ADDENDUM NO.: 2

DATE OF ADDENDUM: December 31, 2014

**MEIGS POINT NATURE CENTER
Hammonasset Beach State Park
Madison, Connecticut
PROJECT: BI-T-601**

SLAB EDGE/ RATED WALL DETAIL REVISION

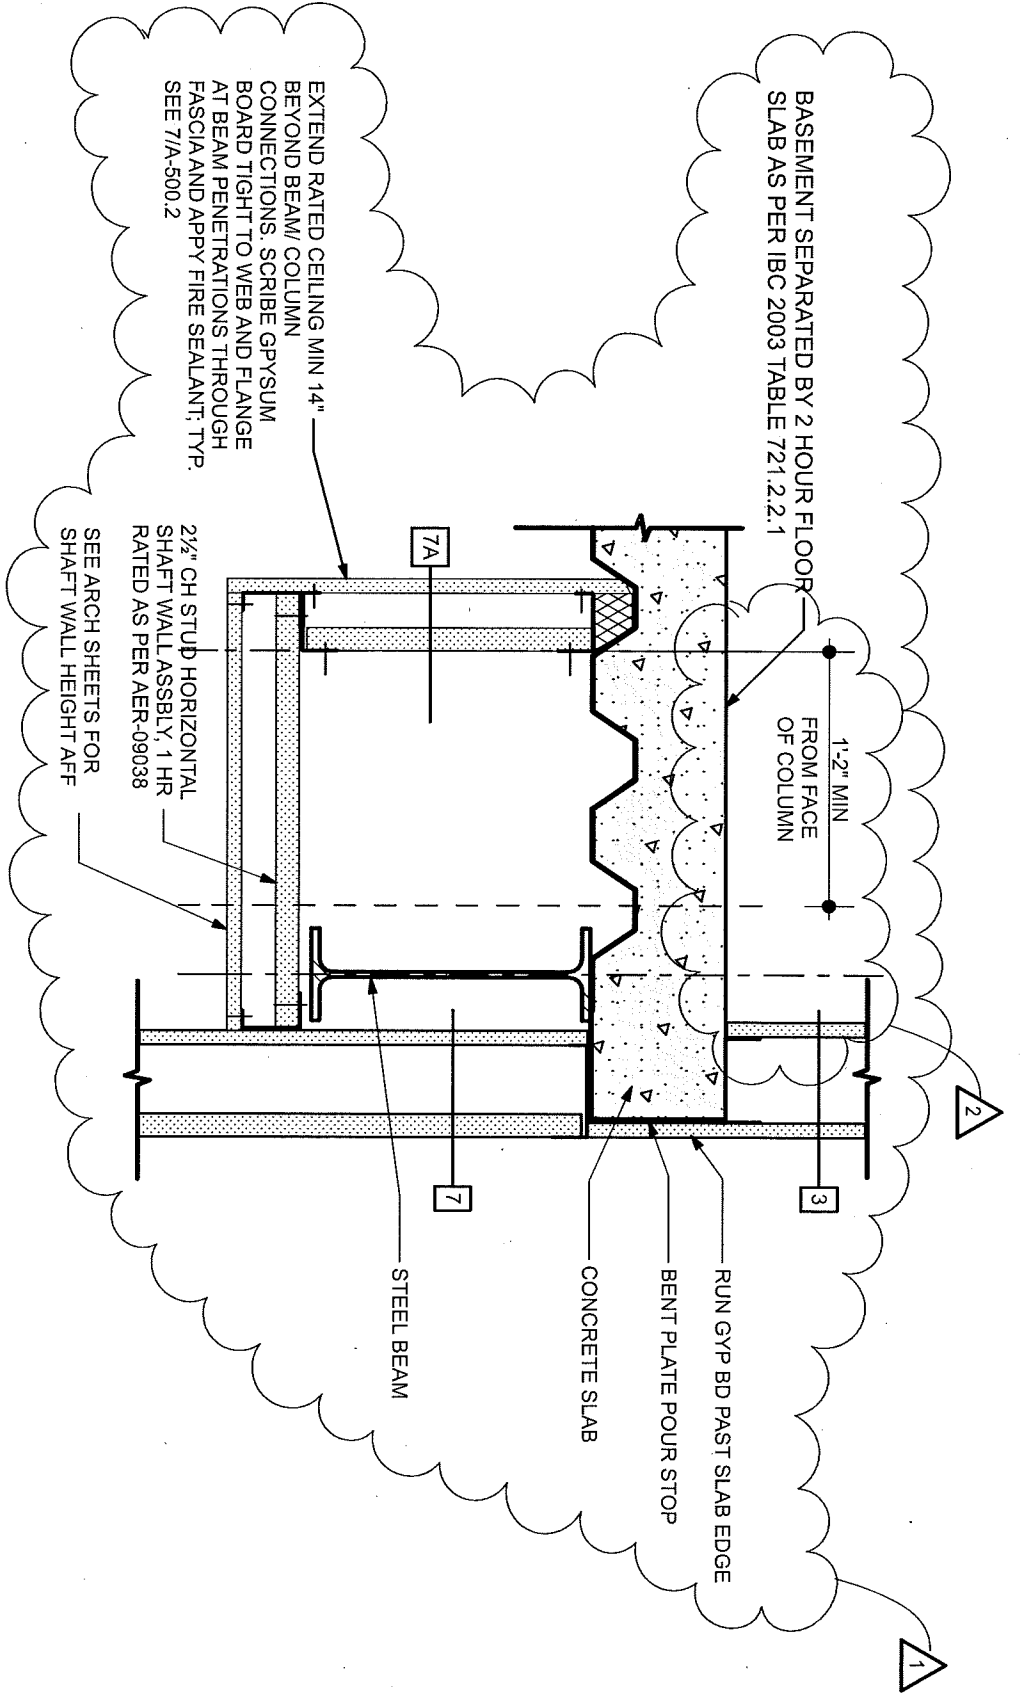
BASEMENT SEPARATED BY 2 HOUR FLOOR
SLAB AS PER IBC 2003 TABLE 721.2.2.1

EXTEND RATED CEILING MIN 14"
BEYOND BEAM/ COLUMN
CONNECTIONS. SCRIBE GYPSUM
BOARD TIGHT TO WEB AND FLANGE
AT BEAM PENETRATIONS THROUGH
FASCIA AND APPLY FIRE SEALANT; TYP.
SEE 7/A-500.2

2 1/2" CH STUD HORIZONTAL
SHAFT WALL ASSBL, 1 HR
RATED AS PER AER-09038
SEE ARCH SHEETS FOR
SHAFT WALL HEIGHT AFF

1 PLAN DETAIL REVISION

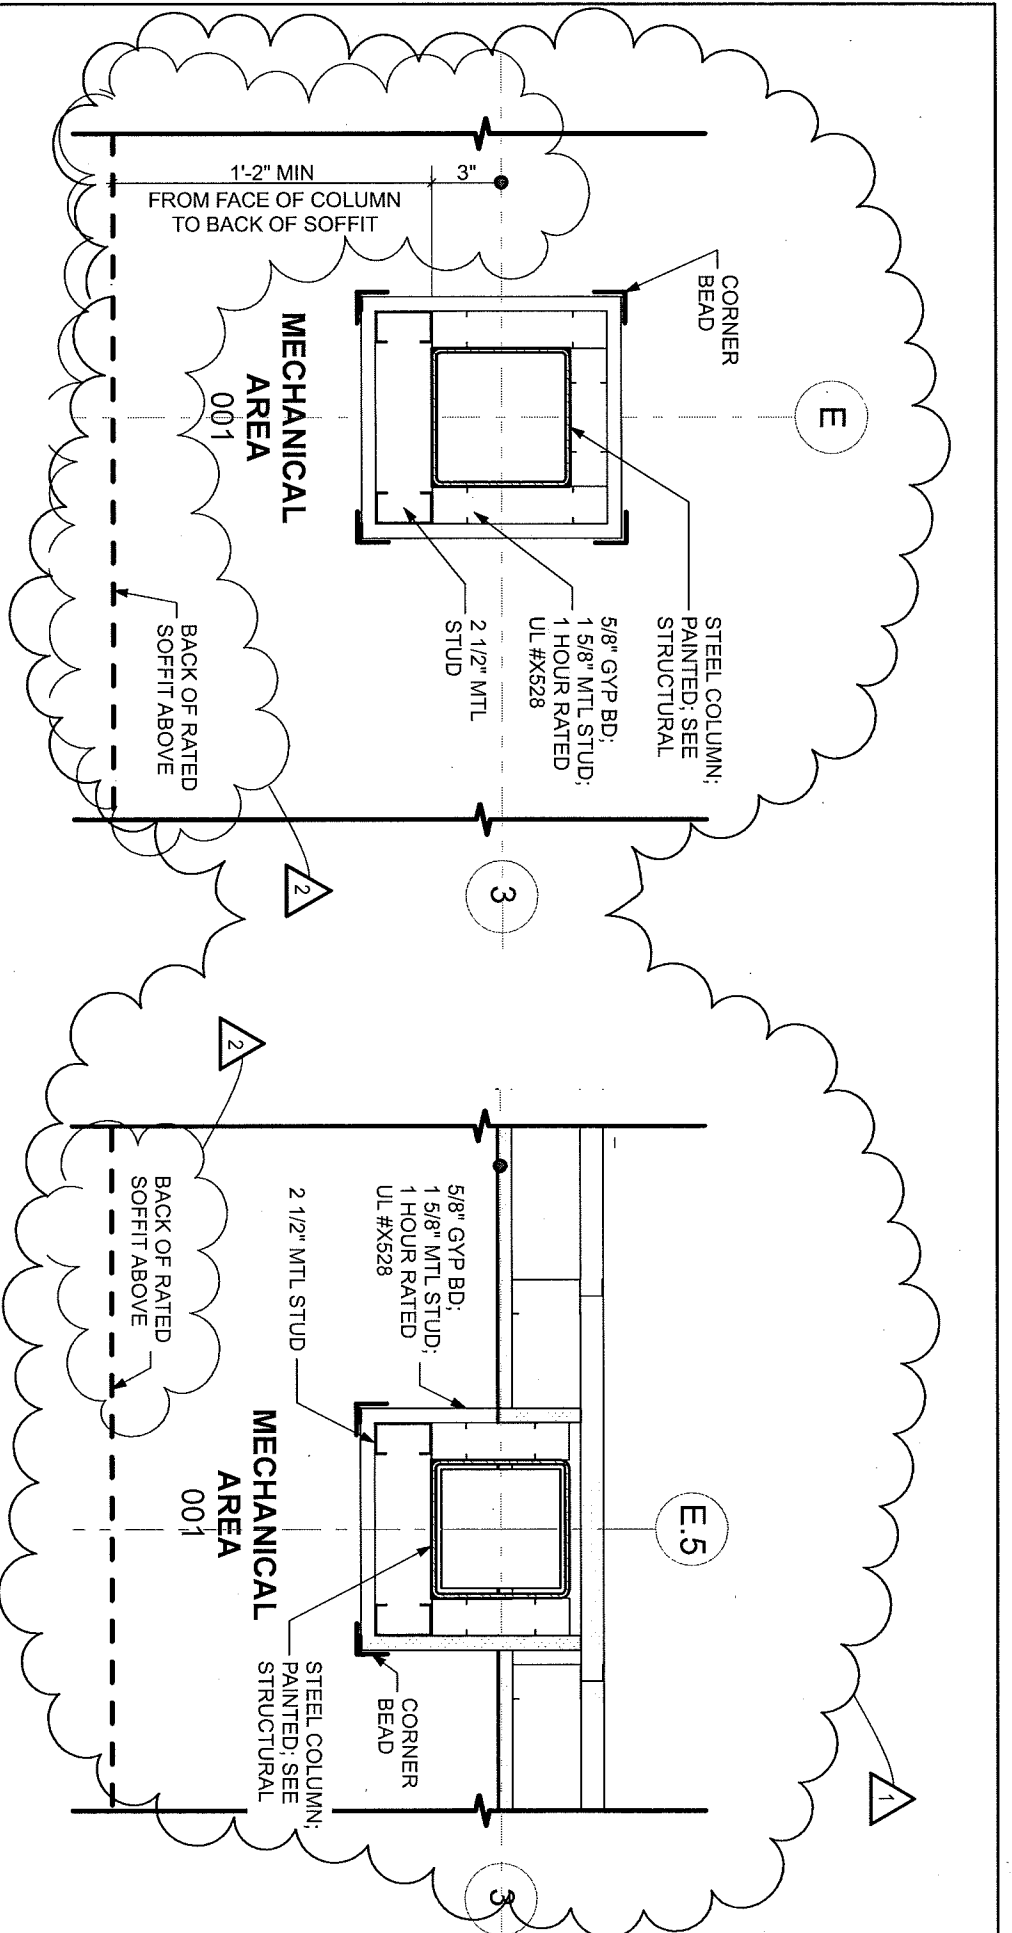
NOTE: SEE DRAWING 9/A-600

NOTE: SEE DRAWING 10/A-600

RESIXED LAVATORY DECK DETAIL

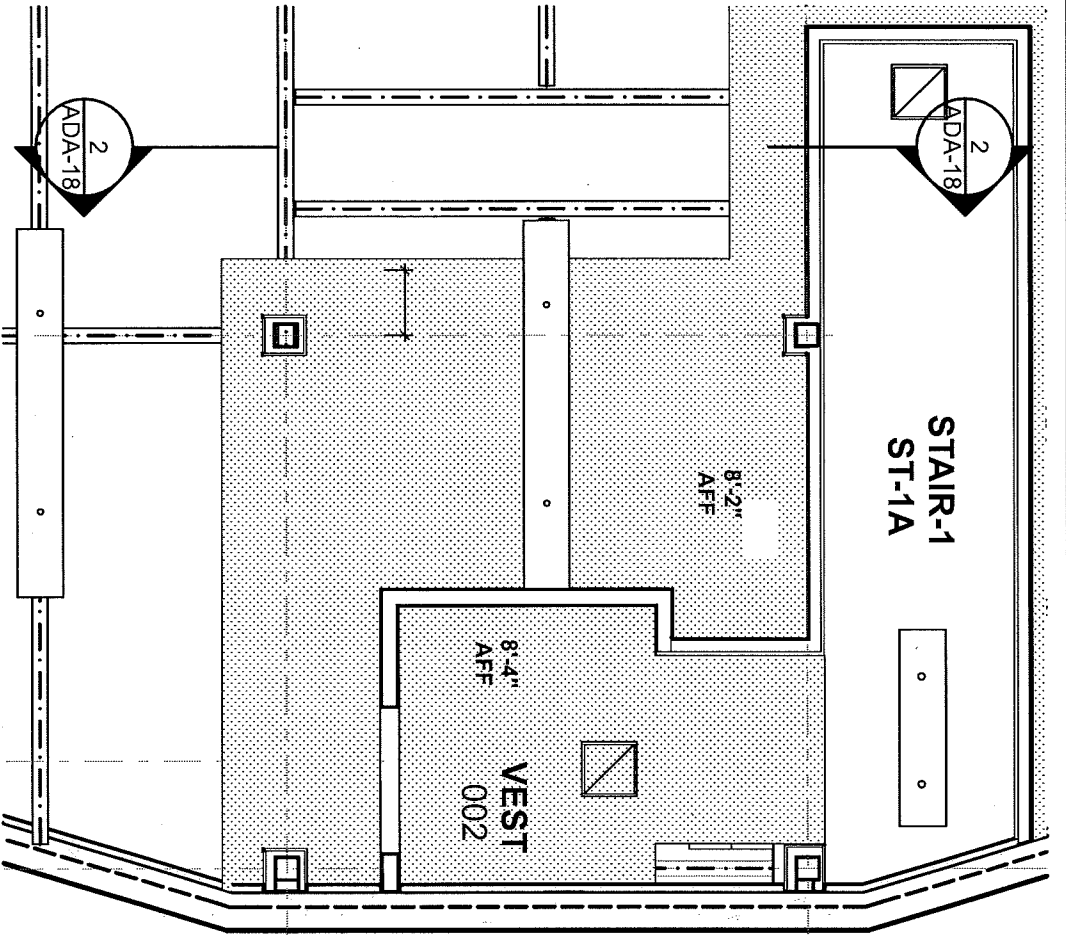
1. As noted on Drawing A-010, all annular spaces in penetrations between the basement and first floor shall be smoketight sealed.
2. All annular spaces in penetrations at slab-on-grade shall be watertight sealed.
3. Use lightweight concrete at first floor slab on grade and raised slab above basement.
4. Stair handrail extensions: At bottom of stairs, handrail shall extend 11 inches with the same slope as the stair before returning to wall or floor or before extending horizontally beyond 11 inches.
5. Accessible lavatories: Refer to Drawing A-001 diagram and provide clearances noted. See also Drawing ADA-17 included in this Addendum.

SEE DIAGRAM "LAVATORY KNEE CLEARANCE" ON SHEET A-001.

PARTIAL BASEMENT RCP

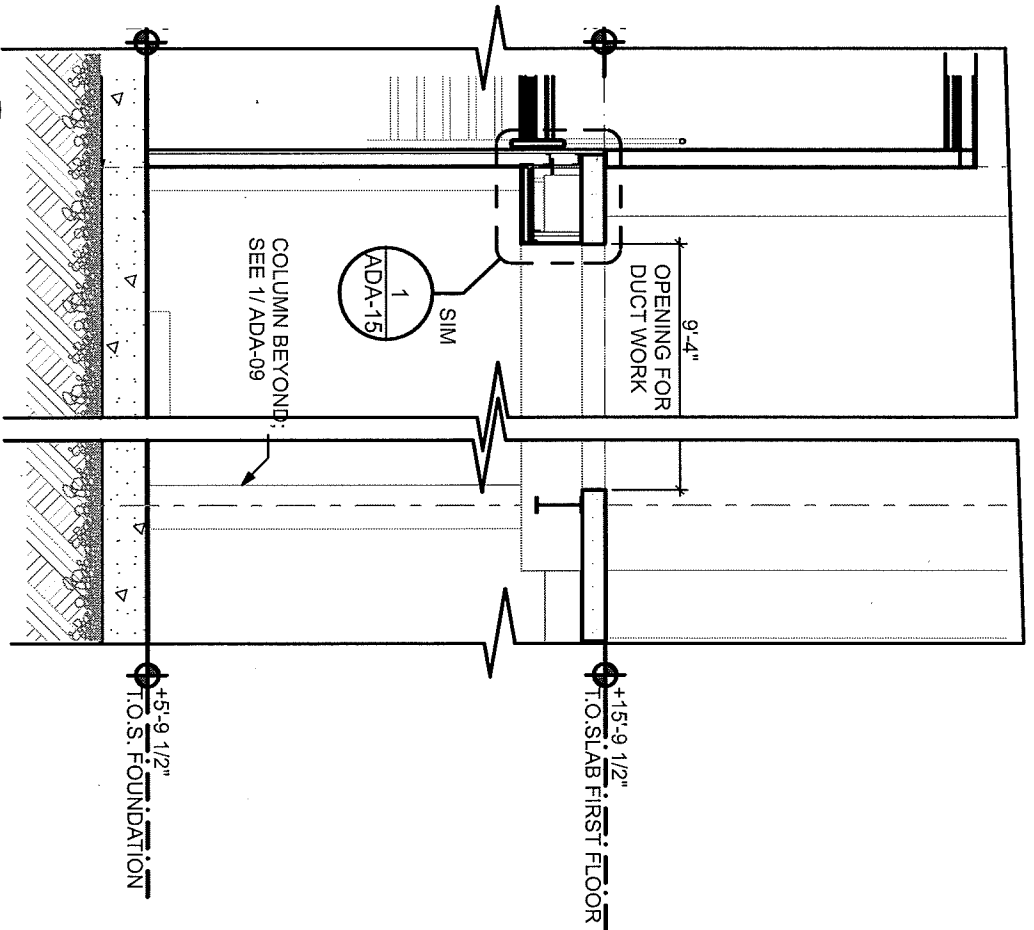
PARTIAL BUILDING SECTION
